Bid Bulletin #01

PROJECT: Gateway Early Childhood Center
Bid Package #2
Omaha, NE

ADDENDUM B

Structural Package
Gateway Early Childhood Center
Omaha, Nebraska
RDG Project No. 2014.129.00, File 35.1

A06.02

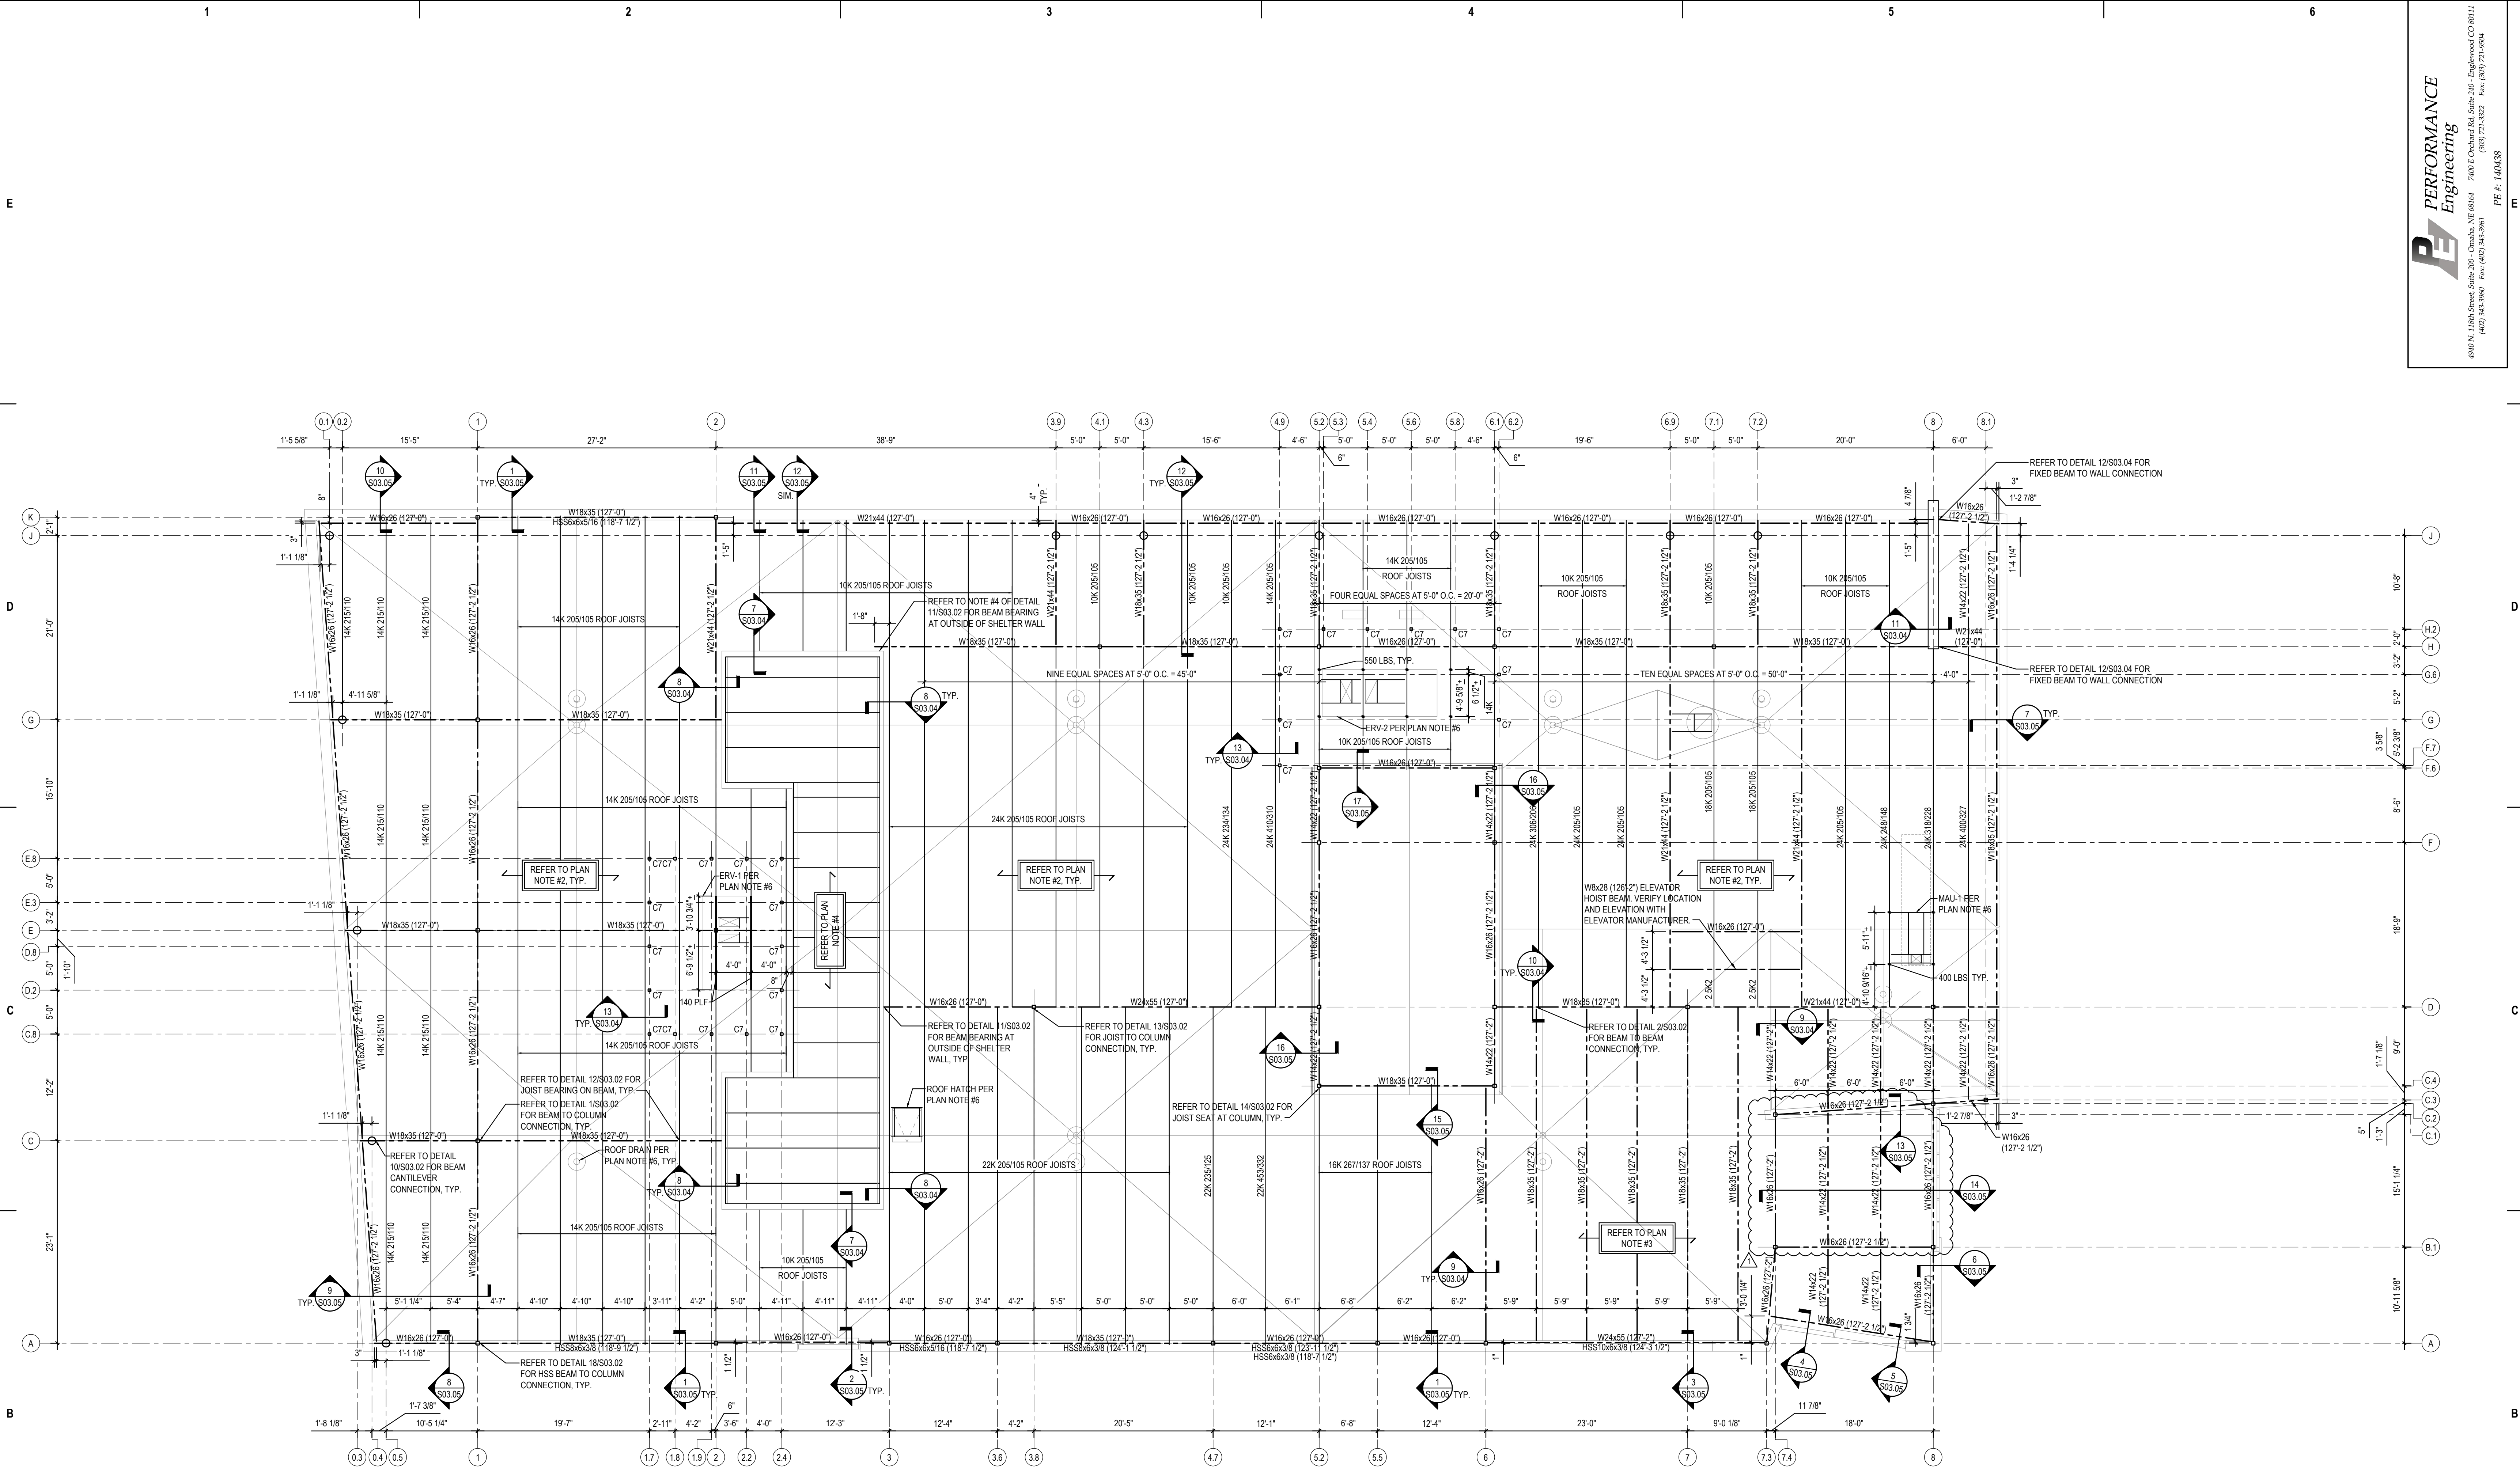
- BGD-1 Sheet A06.01: Sheet has been revised to show structural changes.
BGD-2 Sheet A06.02: Sheet has been revised to show structural changes.
BGD-3 Sheet A07.05: Sheet has been revised to show structural changes.

S02.03

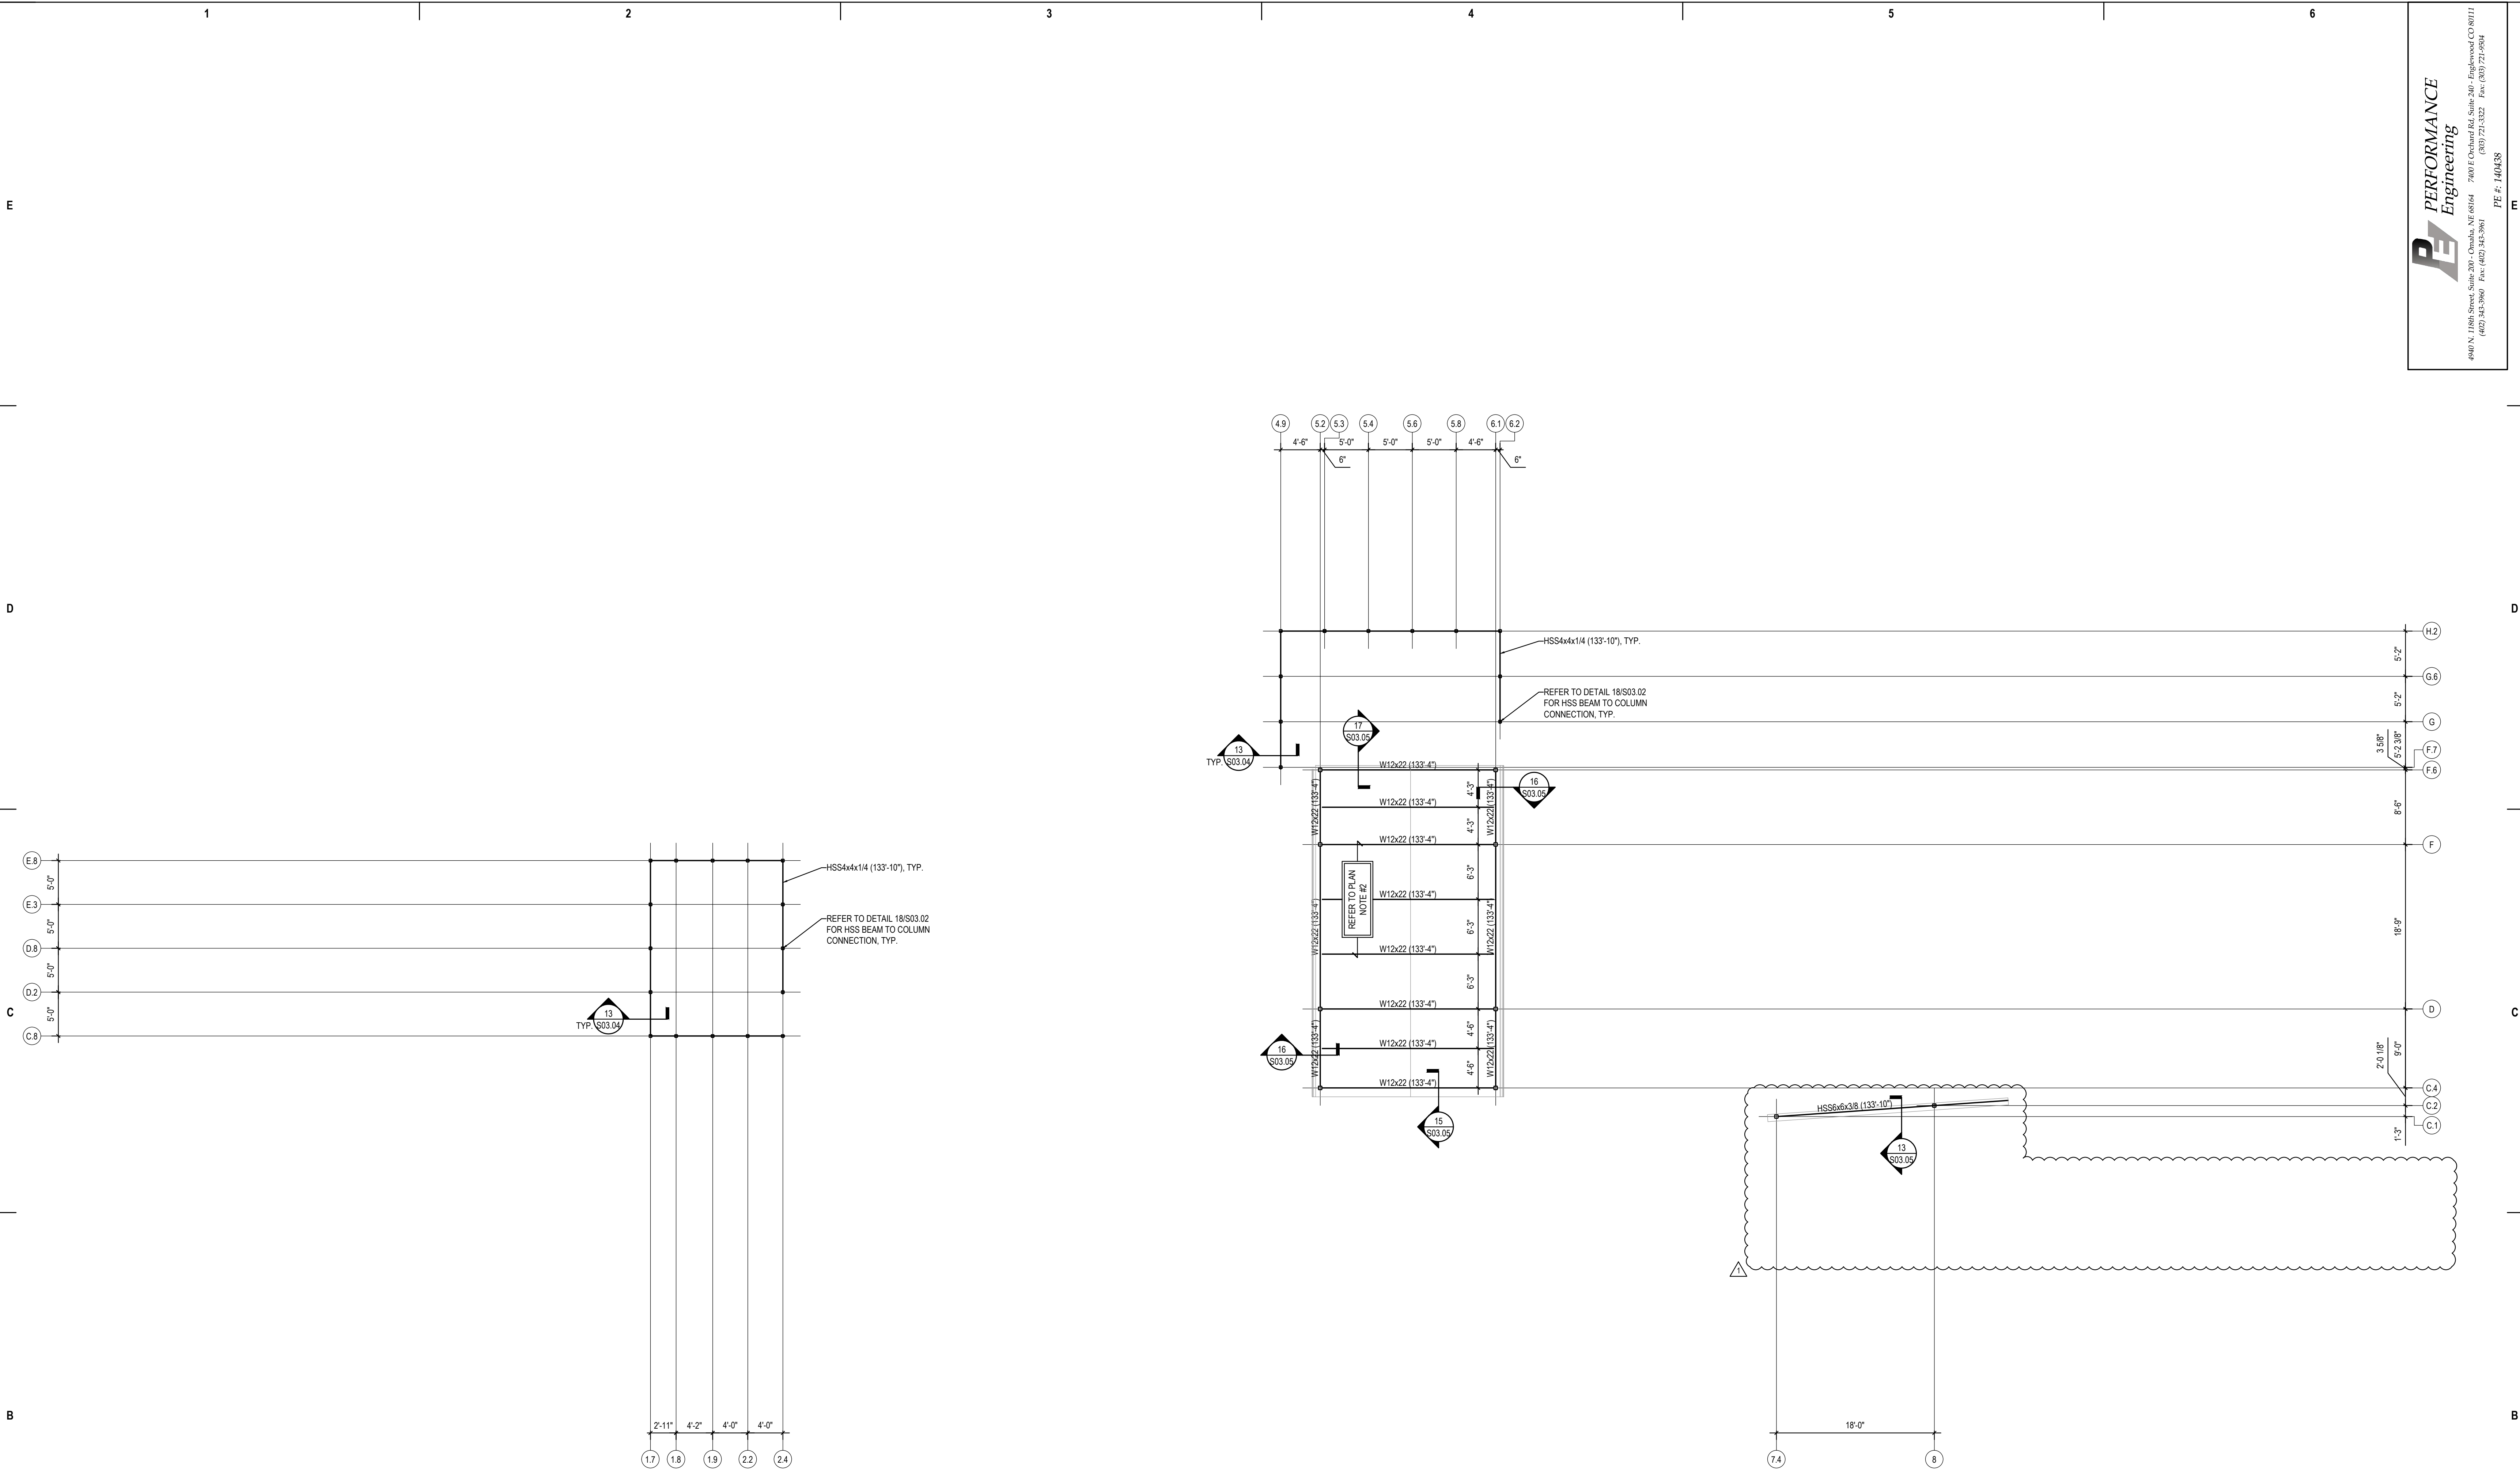
- BSD-3 Sheet S02.03:

- B. Revise framing near front entry as shown.

- A. Add Plan Note #3 as follows:

9. REFER TO SHEETS S01.01 & S02.01 FOR COLUMN SIZES NOT IDENTIFIED ON THIS SHEET.

S03.00

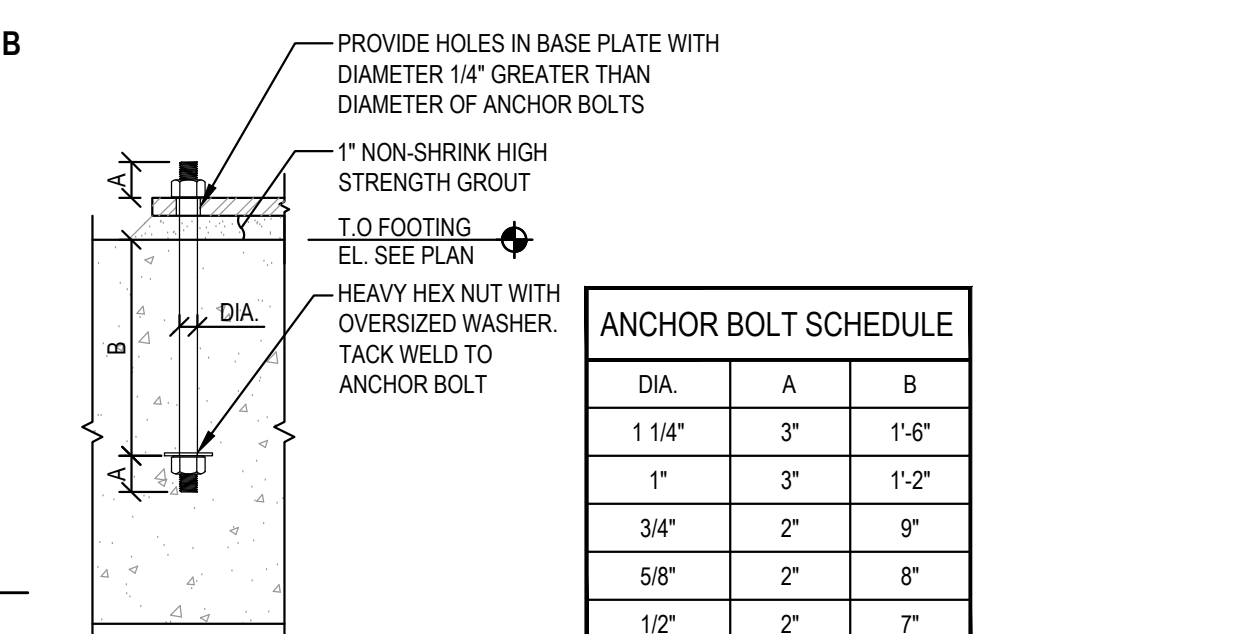
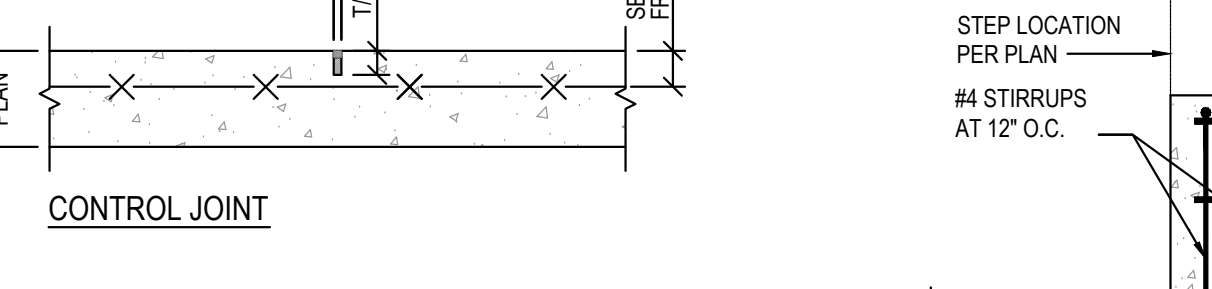
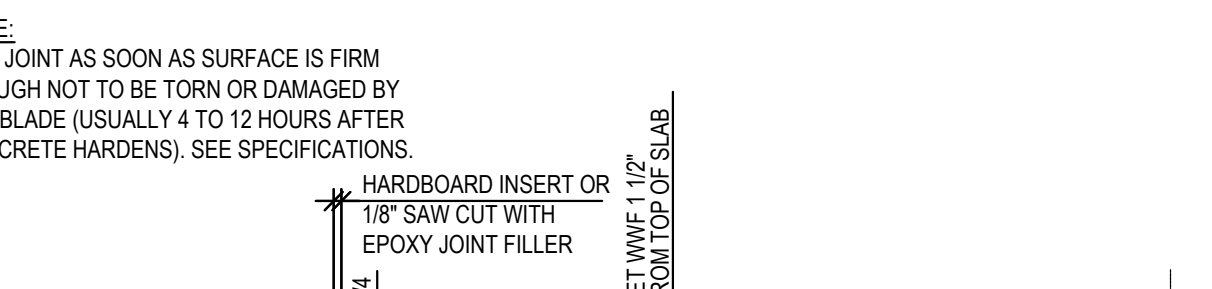
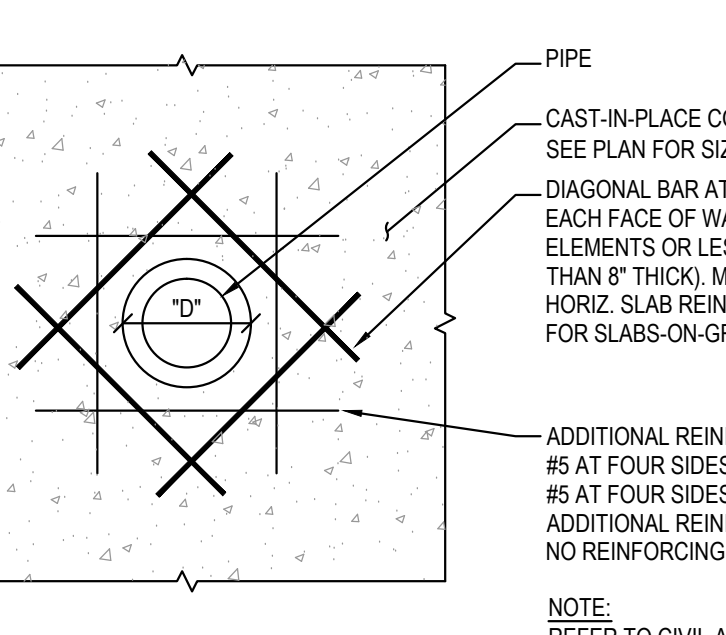
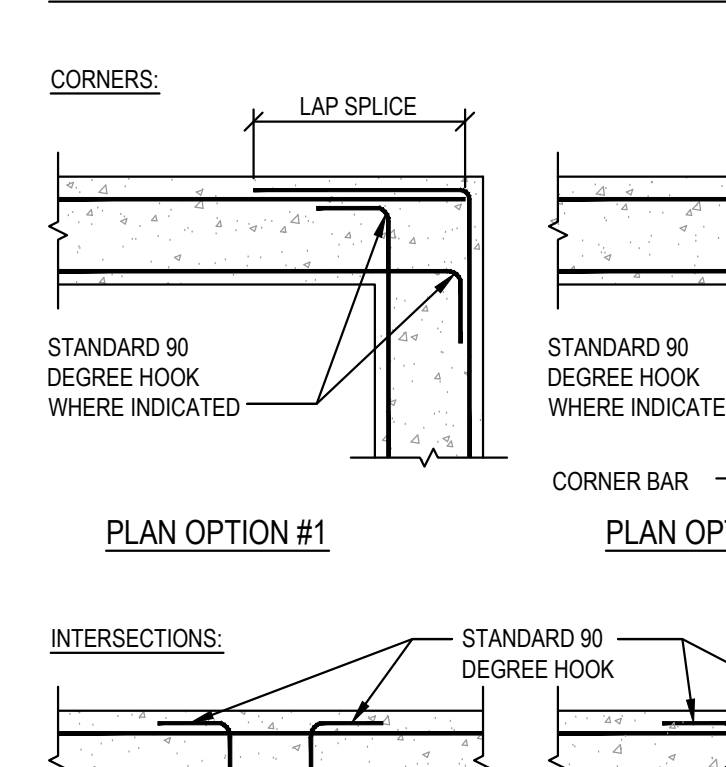
- BSD-4 Sheet S03.00: Revise General Structural Note under Design Loads to read, "**LIVE LOADS = 25 PSF.**"
